2009 ADDENDUM TO THE
ENVIRONMENTAL IMPACT REPORT

San Quentin State Prison Condemned Inmate Complex Project

State Clearinghouse Number 2003122003

June 26, 2009

Modified Warehouse/Support Facilities Plan

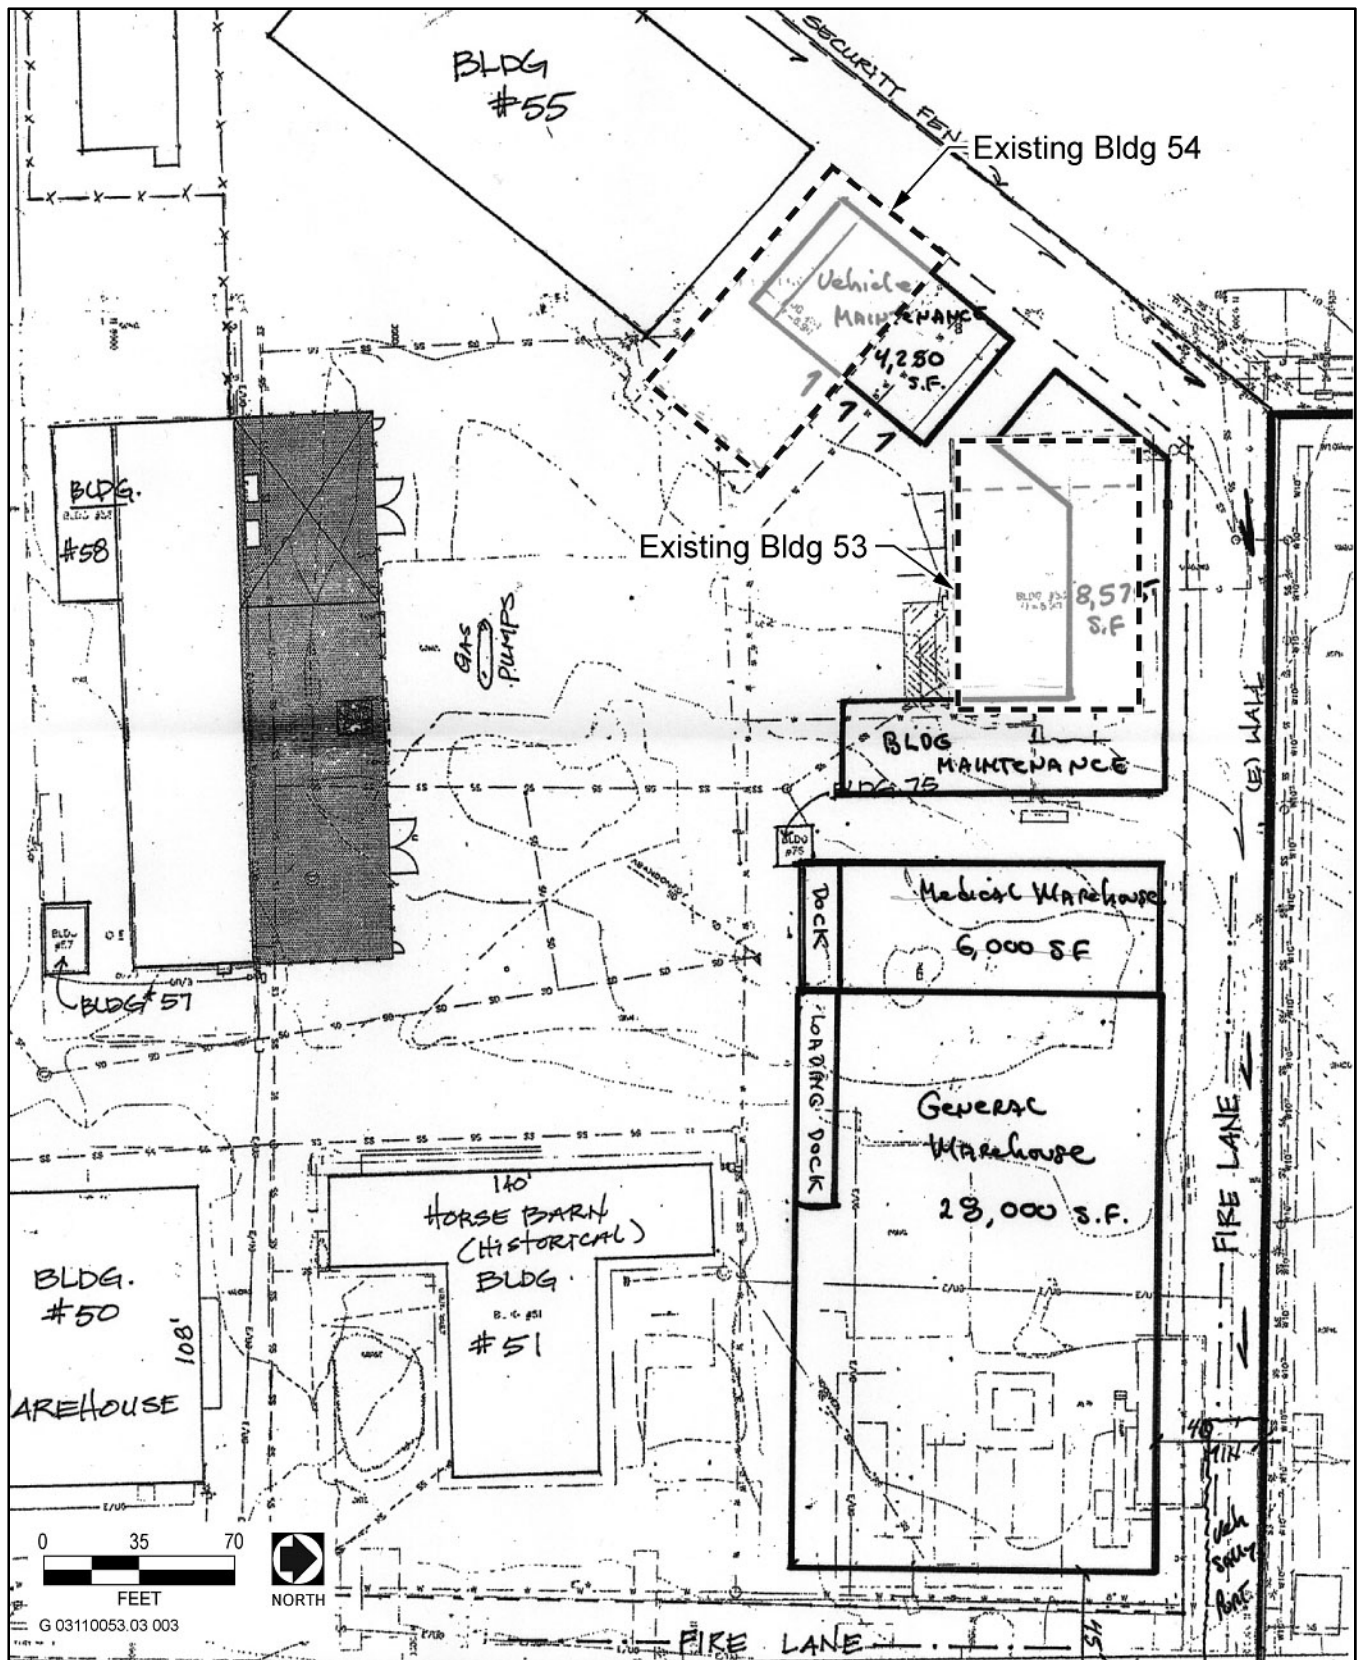
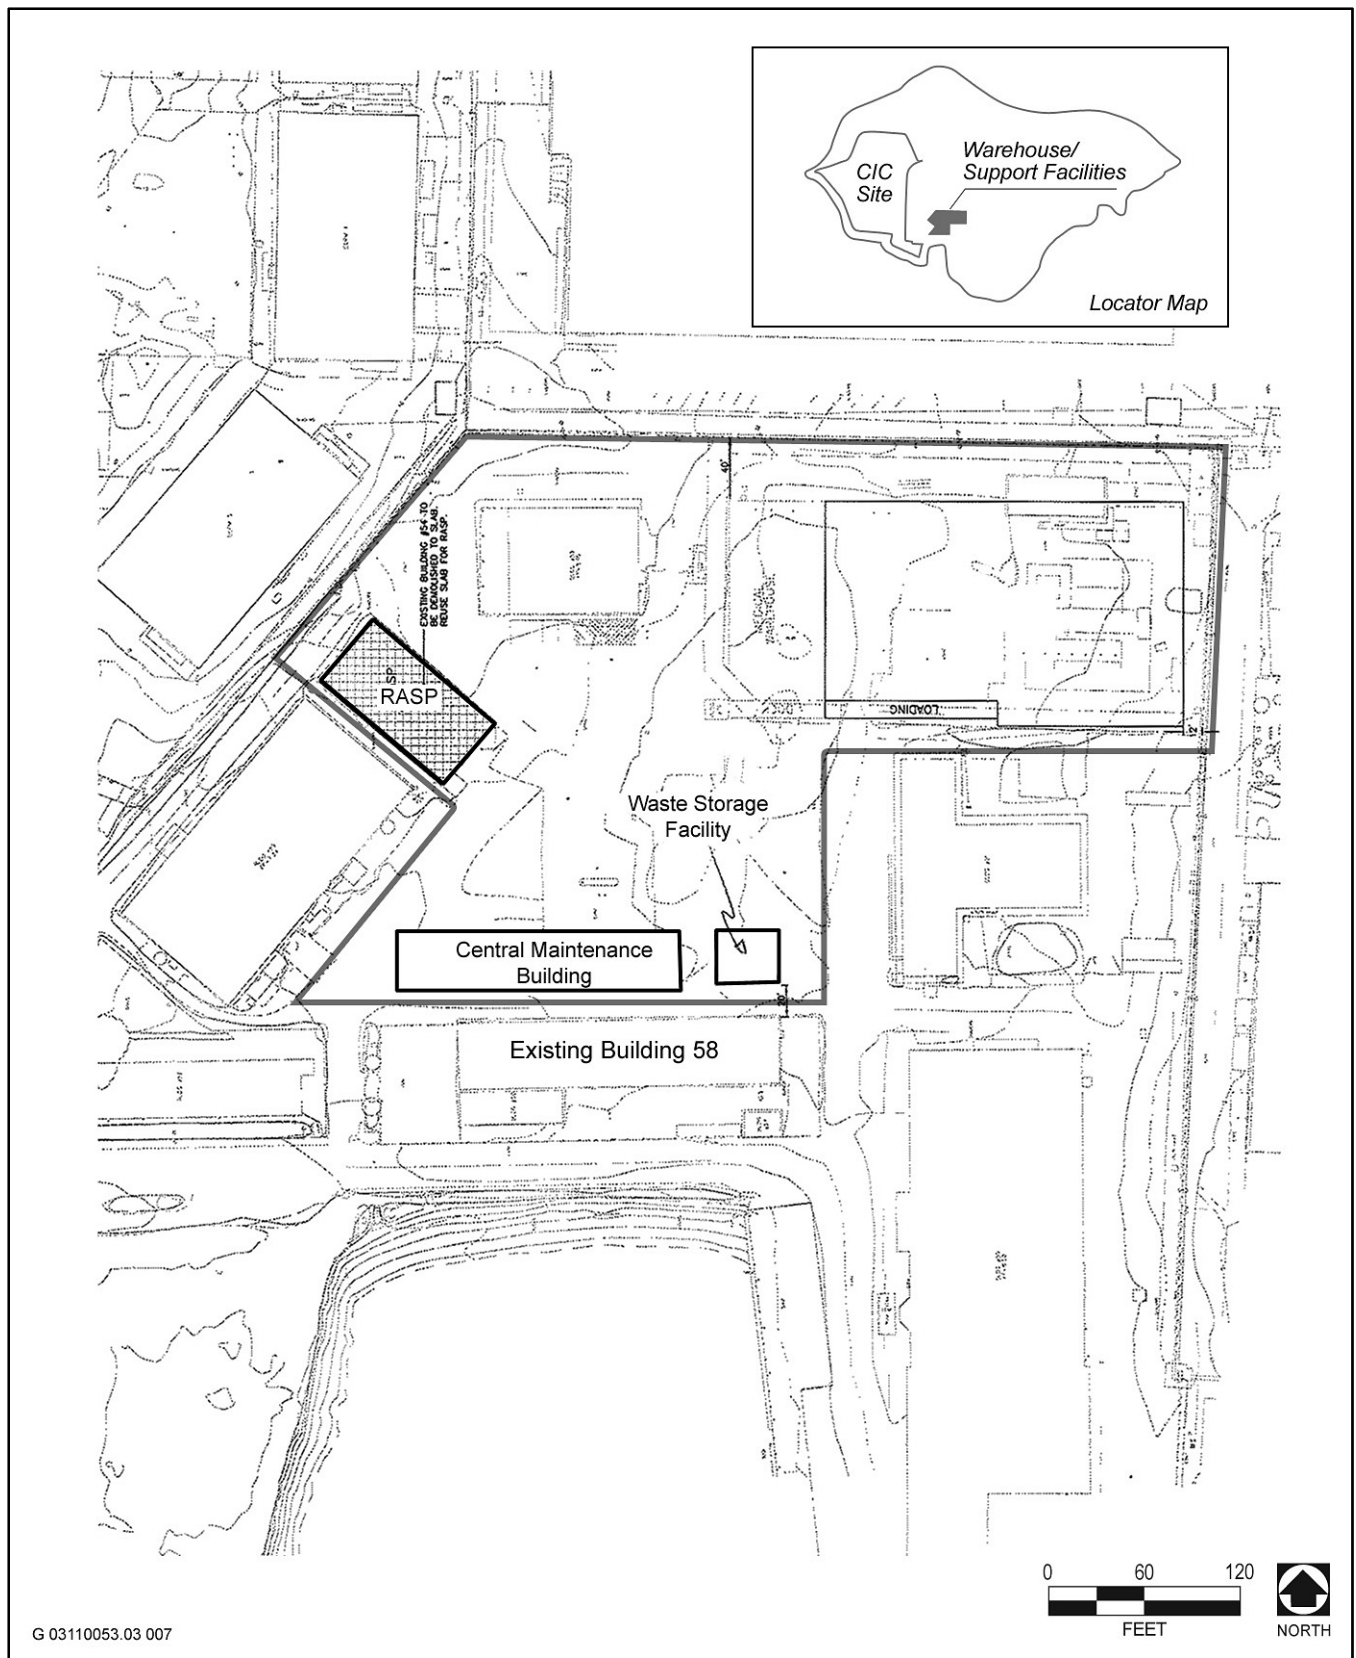
Changes to the warehouse area of the prison would include general relocation and reorientation of support buildings within this area. No new areas of development are proposed. Overall, the area of building space constructed would be reduced from that approved as part of the 2007 CIC site plan. Exhibit 2-9 shows location and footprint of the proposed buildings in the warehouse area of the prison. Currently, buildings in the warehouse area of the prison are not substantially visible from off-site areas, with buildings and landscaping blocking views from Sir Francis Drake Boulevard. The buildings are visible for only a brief (a few seconds) time along the bay to ferryboats traveling from Larkspur Landing and passing the site. Even from this viewpoint, the warehouse area of the prison is largely blocked by intervening structures (a Quonset hut, also known as Building 58, along the waterfront largely blocks the visibility of most of the warehouse area). Buildings proposed within the warehouse

area range from 12 to 25 feet in height, in most instances shorter than warehouse building heights approved in the 2007 CIC Addendum. Further, the mitigation measure in the EIR, which calls for using paint to visually blend buildings in with their surroundings, would further reduce the visibility of the proposed buildings in this location, and make them appear much like the other visible structures. The visual change would not be substantial, and no new significant or substantially more severe visual impacts would occur compared to the EIR.
